RE: American Toyota (File: C18D012)
Drainage Report, Engineer's Stamp Date 3-16-15
Grading and Drainage Plan, Engineer's Stamp Date 7-22-15

RE: Revised Grading Plan (C-18D012)
American Toyota
Albuquerque, New Mexico

The purpose of this letter is to accompany the enclosed revised grading plan. The plan has been revised to accommodate your written comments dated 7/17/15. The following is a summary of your comment and the narrative as to how we addressed. The numbering corresponds to the comments in the letter

PROPOSED LAYOUT (SYSTEM #5)

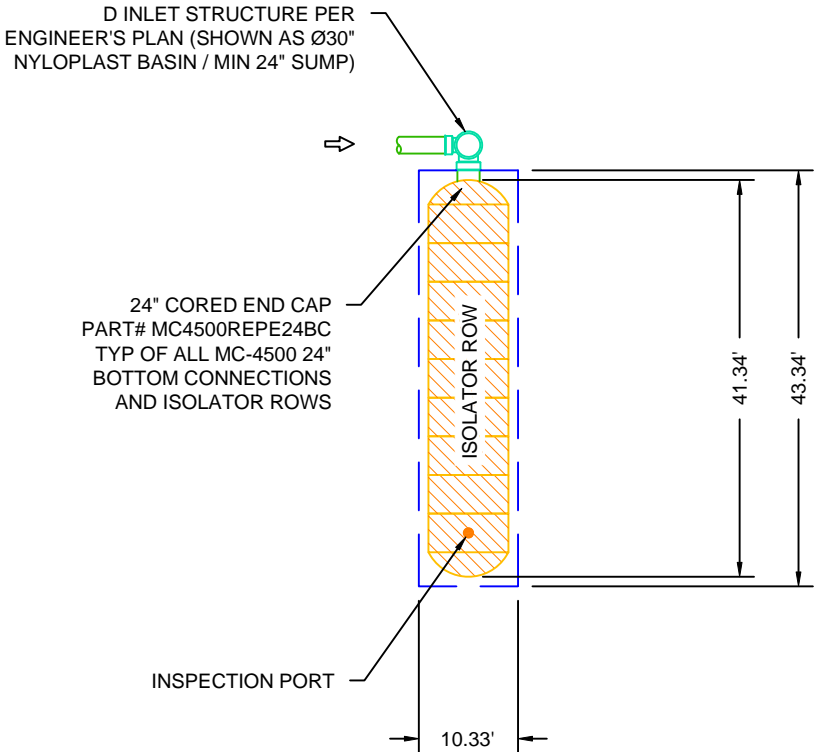
7. System#5 has been modified such that the inlet is connected to the existing line via a type c Manhole with a concrete baffle that will limit discharge once the desired water surface elevation is reached. This allows the system to completely fill prior to discharging.

9. System #5 has been modified such that the inlet is adjacent to and .25' below the outfall of this basin, the system will completely fill and then the basin will discharge to eagle rock

PROPOSED LAYOUT (SYSTEM #6)

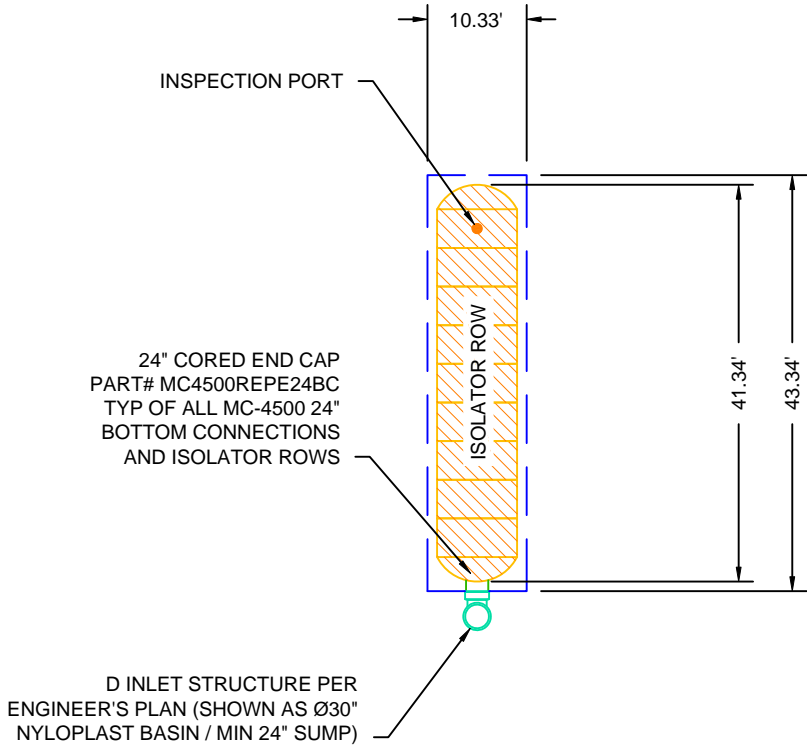
4. We have added note #6 stating all manifolds to be 24"
5. We have added the capacity of the inlets base upon the wier equation.
6. System#6 has been modified such that the inlet is connected to the existing line via a type c Manhole with a concrete baffle that will limit discharge once the desired water surface elevation is reached. This allows the system to completely fill prior to discharging.

ENGINEER'S SEAL	AMERICAN TOYOTA	DRAWN BY WCWJ
		DATE 7-22-15
DAVID SOULE P.E. #14522	GRADING AND DRAINAGE PLAN <i>Rio Grande Engineering</i> 1806 CENTRAL AVENUE SE SUITE 201 ALBUQUERQUE, NM 87106 (505) 872-0999	21403-LAYOUT-1-25-14
		SHEET # — JOB # 21403

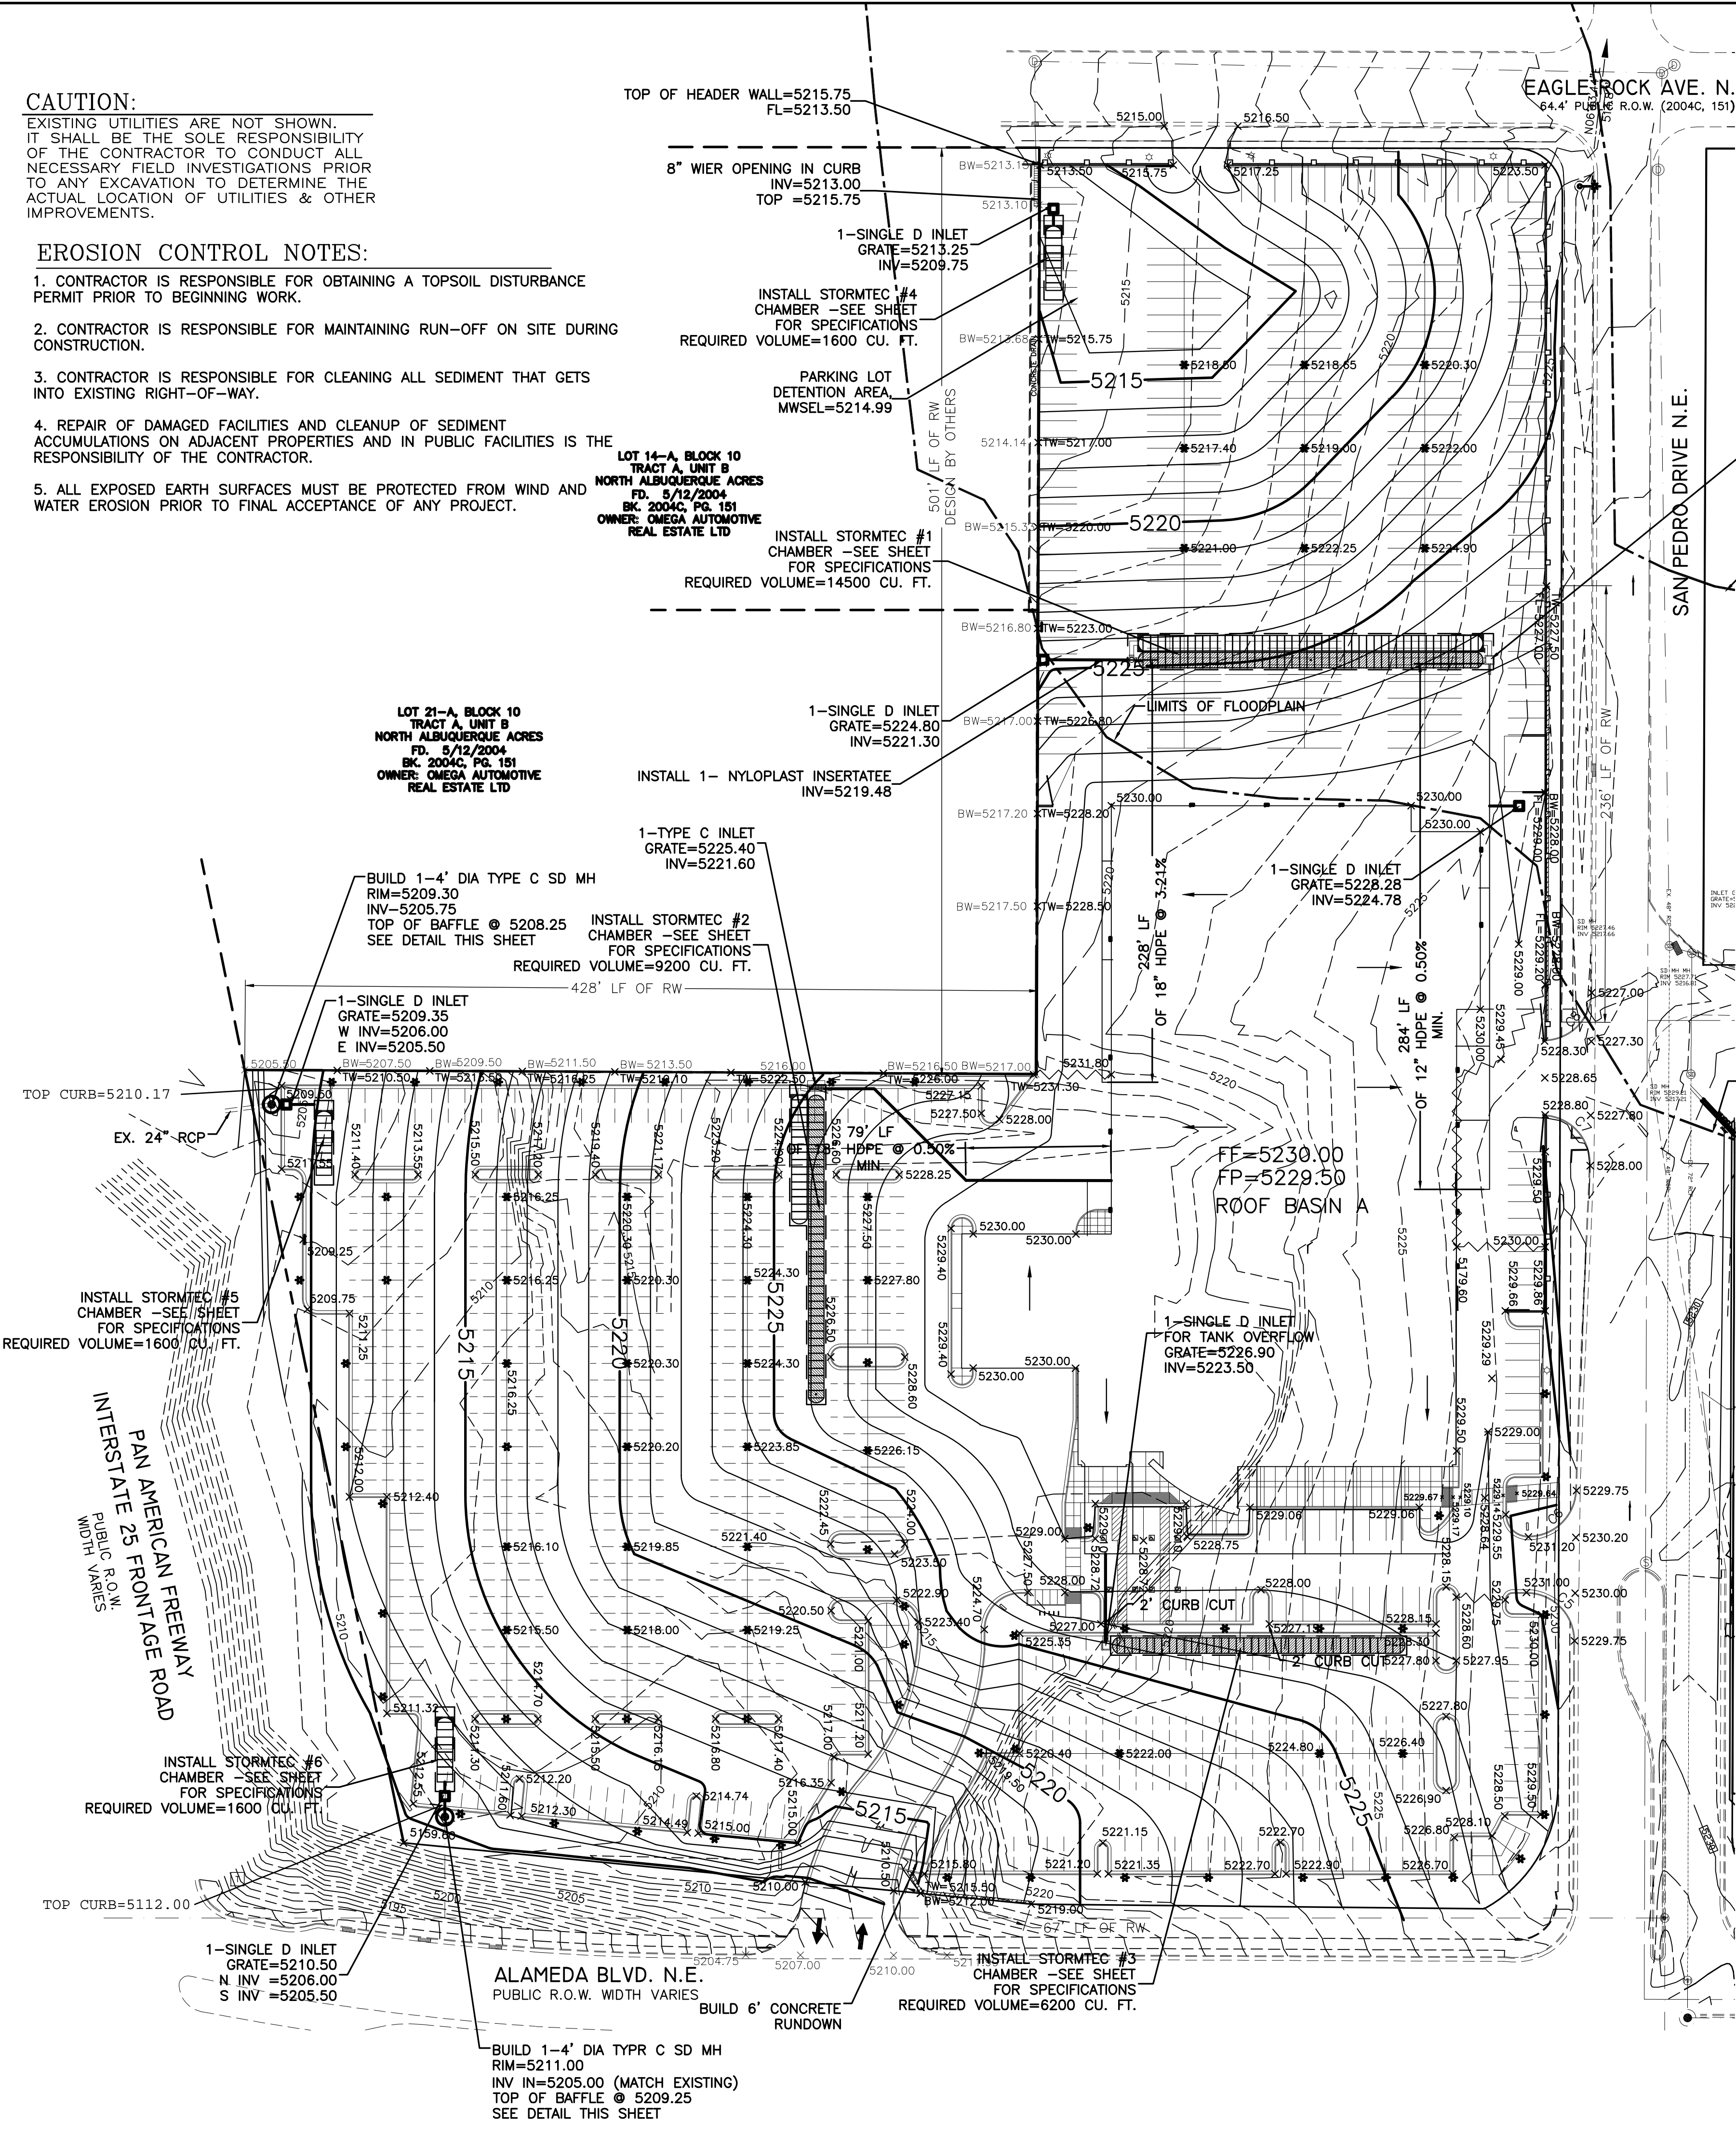
1. This is an informational comment, no action taken
2. We have labeled the pipes and added note #5 stating all pipes not labeled shall be 18".

The city standard details 2102 and 2206 have been added to the plan set to show how pipe and inlet/manholes are to be constructed,
3. We have labeled the storm tech systems
